# Moss Vale Plastics Recycling and Reprocessing Facility

## Response to Submissions Report

Plasrefine Recycling Pty Ltd

10 March 2023

Figure 5.9 Updated water balance

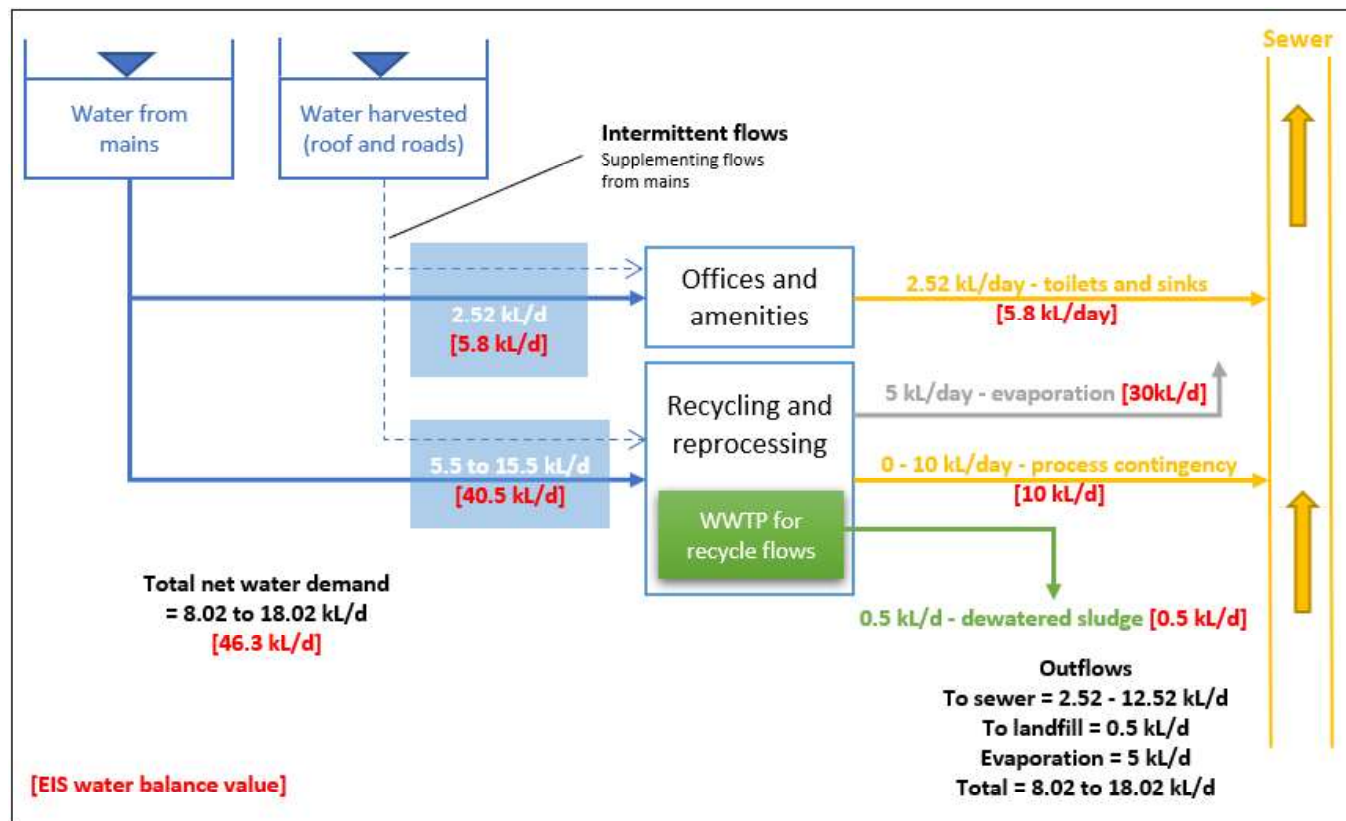
In light of Wingecarribee Shire Council's advice, an updated water balance (refer Figure 5.9) has been prepared that shows reduced water demand and wastewater disposal quantities. The previous quantities of water and wastewater that were reported in the EIS are shown in red and in brackets for comparison.

The updated water balance shown as Figure 5.9 shows that daily water demand would be reduced from 43.5 kilolitres per day to between 8.02 and 18.02 kilolitres per day (depending on whether it is necessary to discharge up to 10 kilolitres per day of wastewater to sewer each day. This represents a 60% reduction in water demand at full plant capacity. The water demand is estimated based on full operational capacity of the proposal and represents the maximum water demand.

As shown in the updated water balance (Figure 5.9), the wastewater discharge quantity is proposed to be reduced from 15.8 kilolitres per day to between 2.52 and 12.52 kilolitres per day. This is based on upgrading of the on-site WWTP so that it can effectively operate as a zero discharge facility. An allowance for discharge to sewer of up to 10 kilolitres per day for industrial wastewater would still be proposed, however wastewater could be tankered off site for treatment at Berrima Wastewater Treatment Plant if there was insufficient treatment capacity at Moss Vale Wastewater Treatment Plant until Council's planned upgrading occurs, noting that this quantity is not expected to be generated prior to 2026.
